PALMER WOODS SUBDIVISION, **PHASE III**

APPLICATION NUMBER 17 DATE April 5, 2007

DETAIL SITE PLAN

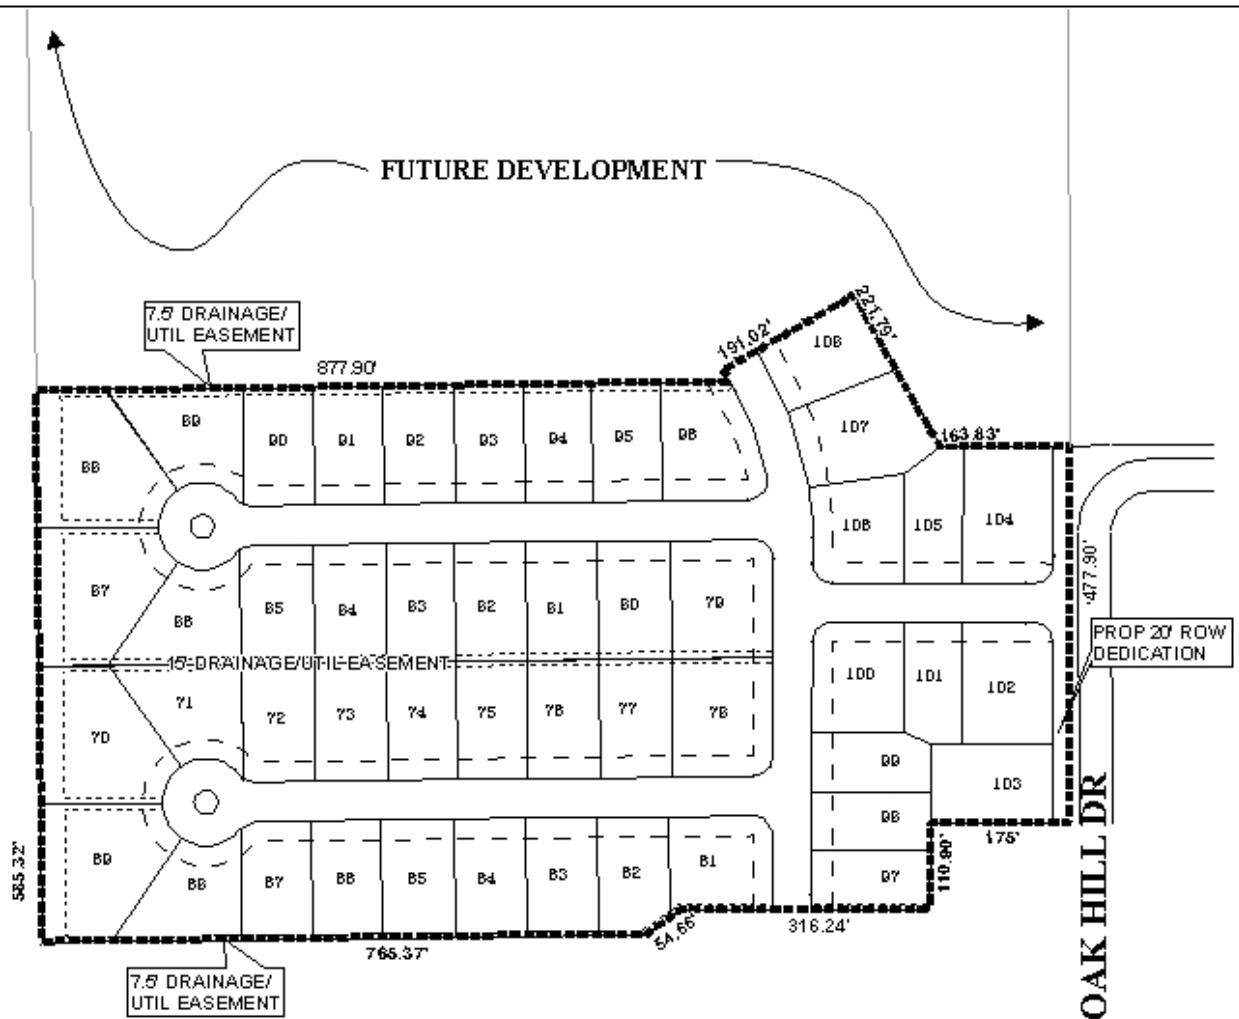
Oak Hill Drive, which has an existing right-of-way of 60-feet, is a proposed major street (Magee Road) on the Major Street Plan, and as such requires a 100-foot right-of-way. Therefore, as illustrated on the preliminary plat the dedication of sufficient right-of-way to provide 50-feet from the centerline of Oak Hill Drive, should be required.

With the site being located on a major street, access management is a concern; therefore, the placement of a note on the Final Plat stating that Lot 103 is allowed one curb cut to Oak Hill Drive, with the size, location and design to be approved by Mobile county Engineering, should be required. As proposed, Lots 102 & 104 would have frontage along Oak Hill Drive and the new street; therefore, the placement of a note on the Final Plat that Lots 102 and 104 are denied direct access to Oak Hill Drive, should be required.

As stated on the subdivision application public water and sewer would be provided; however, MAWSS comments state that NO water or sewer services are available. Based on the preliminary plat the majority of the lots do not meet the minimum requirements of Section V.D.2 “Where served by neither the public or an approved private water supply system nor sanitary sewer system the minimum lot size must be at least 20,000 square feet”.

Prince Court and Collie Court, the cul-de-sacs proposed for this phase of the subdivision, are approximately 720± feet long, which exceeds the 600-foot length, recommended in Section V.B.6. of the Subdivision Regulations. Therefore, a waiver of Section V.B.6 would be required.

The requirement for street-stubs to the North is based upon Section V.B.1. of the Subdivision Regulations, which states: “The street layout shall also provide for the future projection into unsubdivided lands adjoining of a sufficient number of streets to provide convenient circulation.” The remaining parcel of the site is approximately 77 acres, and is likely be the subject of future subdivision applications, hence the recommendation for street-stubs.

While the site is in the County, the applicant's engineer will be required to certify that the stormwater detention, drainage facilities, and release rate comply with the City of Mobile stormwater and flood control ordinances, prior to the signing and recording of the final plat, if approved. The plat should also be revised to depict lot sizes to be illustrated in square feet either through labeling or the provision of a table on the Final Plat.

Based upon the preceding, the application is recommended for Holdover until the May 3rd Commission meeting, with revisions due by April 9th, to address the following:

- 1) the dedication of sufficient right-of-way to provide 50-feet from the centerline of Oak Hill Drive;
- 2) the placement of a note on the Final Plat stating that Lot 103 is allowed one curb cut to Oak Hill Drive, with the size, location and design to be approved by Mobile County Engineering;

- 3) the placement of a note on the Final Plat stating that Lots 102 and 104 are denied direct access to Oak Hill Drive;
- 4) provision of the minimum requirements of Section V.D.2;

- 5) provision of a certification letter from a licensed engineer to the Planning Section of Urban Development, certifying that the stormwater detention, drainage facilities, and release rate comply with the City of Mobile stormwater and flood control ordinances, prior to the signing and recording of the Final Plat;

- 6) placement of a note on the plat stating that any lots which are developed commercially and adjoin residentially developed property must provide a buffer, in compliance with Section V.A.7. of the Subdivision Regulations; and

- 7) labeling of all lots with size in square feet, or placement of a table on the plat containing the lot size information.
